APS 2K BAFFLE
 SEE D000246 FOR 4K BAFFLE

REF. MAKE 1 PER ASSEMBLY		UNLESS OTHERWISE SPECIFIED DIMENSIONS ARE IN INCHES		REF. QTY	PART or DRWG No.	DESCRIPTION	MATERIAL			
TOLERANCES:		THREE PLACE DECIMAL ±.005		PARTS and MATERIAL LIST						
FRACTIONAL ±1/16		FINISHED SURFACE RMS .03		LGD CALIFORNIA INSTITUTE OF TECHNOLOGY						
ANGULAR ±.25°		BREAK CORNERS TO .015 (DUT) .015		ASSEMBLY						
WELDING ±.010		REMOVE ALL BURRS		APS 2K FRONT BAFFLE						
TWO PLACE DECIMAL ±.01				D000085-A						
				REV E						
				D000189-A						
				SCALE 1:1						
				SHEET 1 OF 1						
DWG. NO.	DESCRIPTION	MATERIAL	HEAT TREAT	REV	DESCRIPTION	DCN NUMBER	APPR'D	CHECK	DRWN	DATE
	REFERENCE DRAWINGS	ALUMINUM TOOLING PLATE	/	00	NEW RELEASE	LGD-E000256-00-D				5-23-99
		USED ON XXX		00	PRE-RELEASE					11-3-98
				REV	DESCRIPTION					
					ISSUE DESCRIPTION

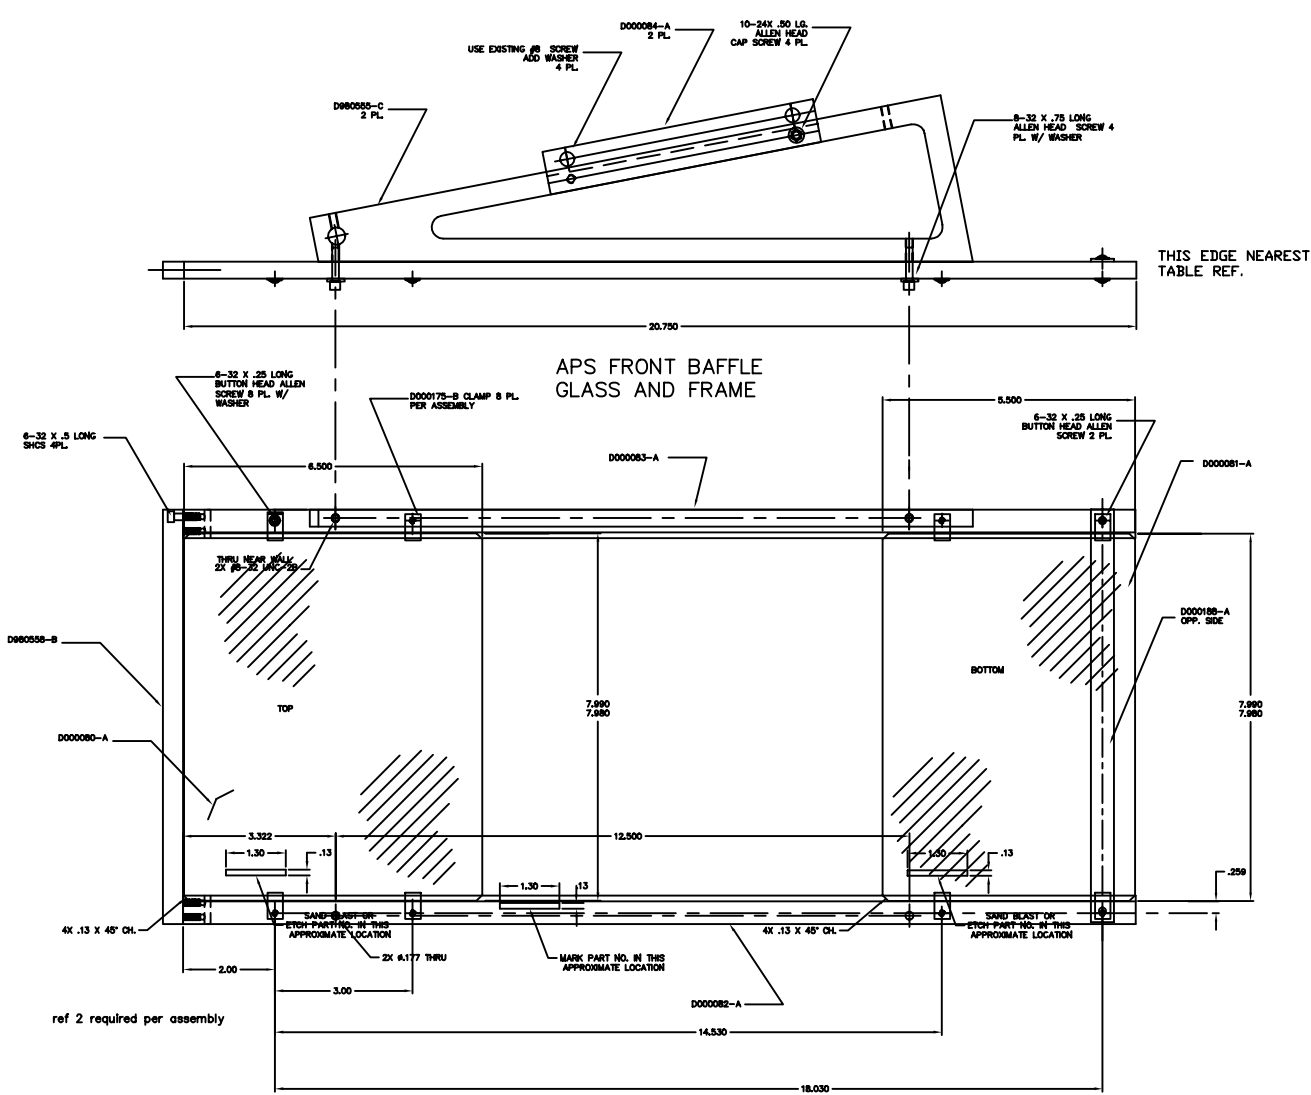
~~Liquid petroleum products, lubricants~~
 Fluids containing hydrocarbons or other contaminants, other than the working fluids specified herein, shall not be allowed to come into contact with suspension material at any time. All working fluids shall be water soluble and free of sulfur, chlorine and silicon such as Chevron's Macron's Citracel 410 (waterless steel).

~~Identification: Part Number~~
 A serial number shall be etched, or scribed on the part see note drawing note.

The Serial number shall be of the format: D990000-x-111

Example: D990002-A-001
 The drawing number, The revision number, The sequential part number.
